BALLOT AGENDA ITEM 653 - 150: 2nd ballot – January, 2008

Proposed Revisions

APPENDIX B – EVALUATION OF TANK BOTTOM SETTLEMENT

Figure B-3—Graphical Representation of Shell Settlement per B.2.2.4

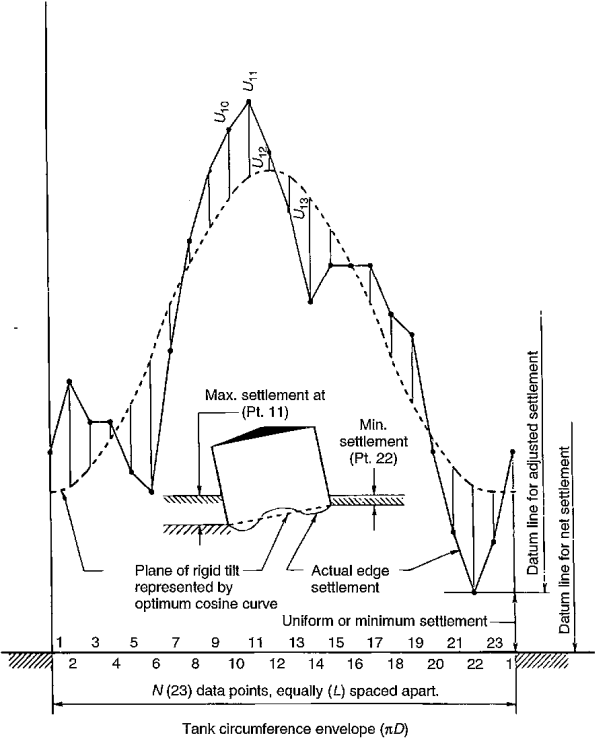
A graphical representation illustrating ~~the effect of tank shell settlement components~~ **with a rigid tilt plane well-defined by a cosine curve fit** is shown in Figure B-3. The construction of this settlement plot has been developed in accordance with the following:

(New Title, Figure B-3 itself UNCHANGED)

Out-of-plane deflection for point "i" is $S_i = U_i - (1/2 U_{i-1} + 1/2 U_{i+1})$, for example $S_{11} = U_{11} - (1/2 U_{10} + 1/2 U_{12})$

U_i = out-of-plane settlement of point "i",
 (+) when above cos. curve,
 (-) when below cos. curve, for example:
 $U_{11} = (+)$
 $U_{13} = (-)$

Figure B-4a–Graphical Representation of Shell Settlement per B.2.2.5 (Tilt Plane Not Described by an Optimal Cosine Curve)

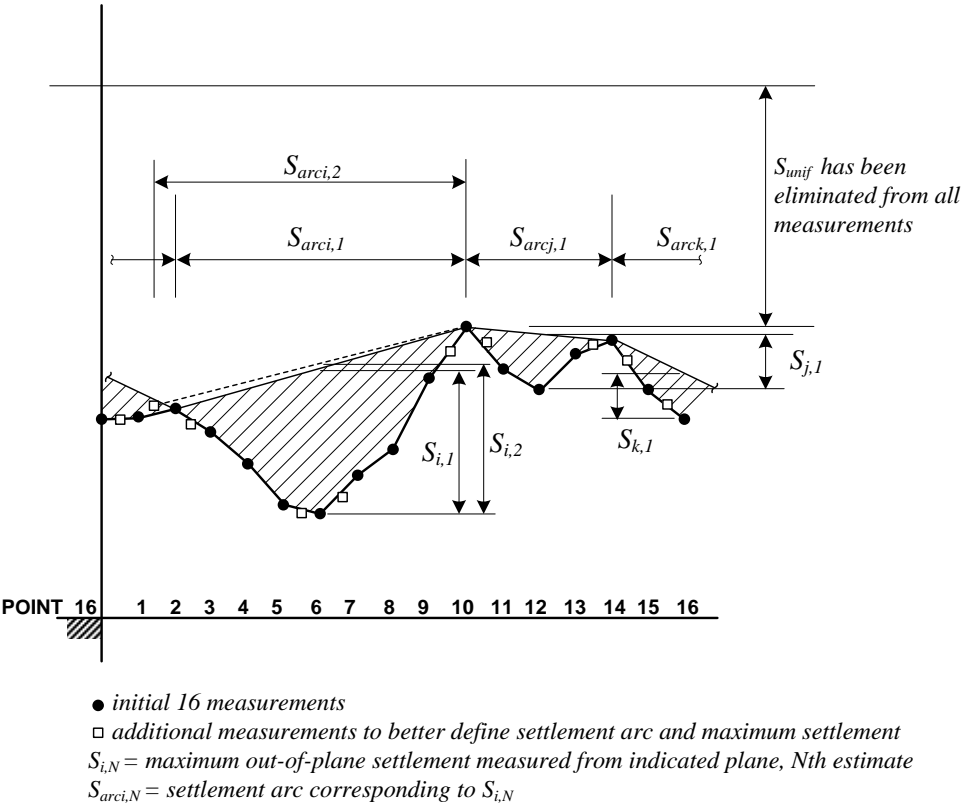
For settlement profiles without a well-defined rigid tilt plane, the settlement arc length, S_{arc} , and out-of-plane settlement at the point under consideration, S_i , must be determined from a plot of the measurement data. Figure B-4a illustrated the various measurement terms and procedures for determining estimates of the settlement arc length and the corresponding out-of-plane settlement, including the refinement of measurements, when needed.

The settlement arc length shall be taken as the circumferential length between points on either side of the maximum out-of-plane settlement point under consideration.

An initial estimate of settlement arc length and maximum settlement should be determined then, additional settlement measurement points may be taken halfway between the points indicating a change in direction of the settlement slope to further refine the settlement arc length and location and magnitude of the maximum settlement.

Depending on location of the new settlement points relative to the initial points, a further refinement of the measurement spacing may be needed.

The best estimate of the settlement arc length and maximum settlement shall be considered in the procedure given in B.3.2.2.

Figure B-4b—Graphical Representation of Shell Settlement per B.2.2.5 (Tilt Plane Described by Optimal Cosine Curve)

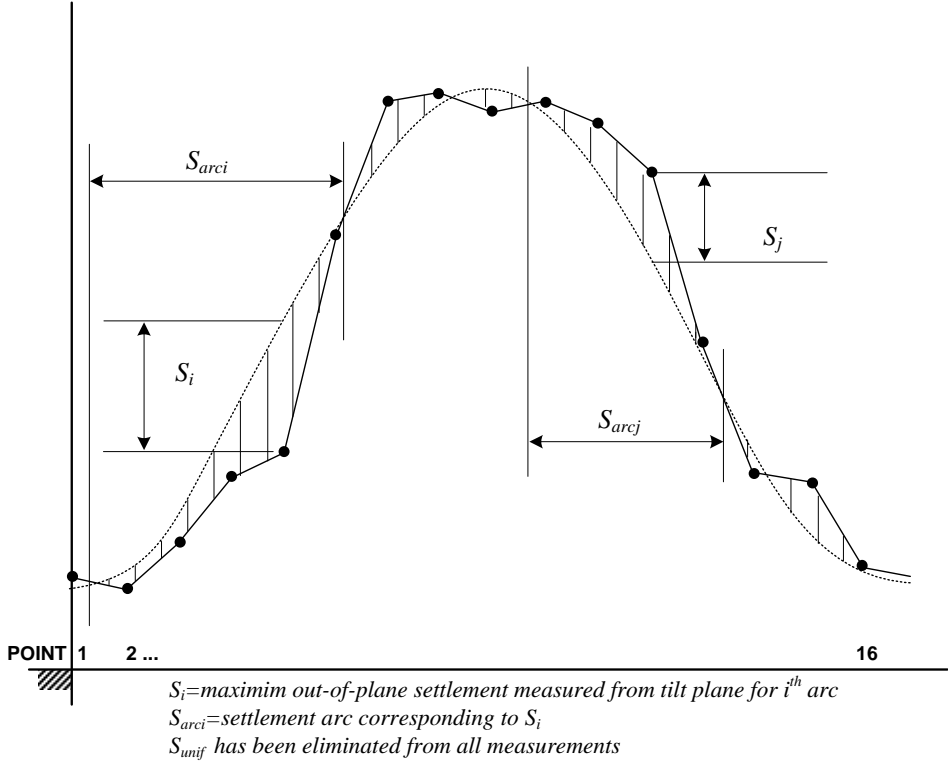
If a valid cosine fit of the rigid tilt plane can be determined, but the maximum out-of-plane settlement determined in accordance with B.3.2.1 is exceeded, the procedure in B.3.2.2 may be used to evaluate the settlement. In this case, refer to Figure B-4b for an illustration of the determination of the settlement arc length and the corresponding out-of-plane settlement.
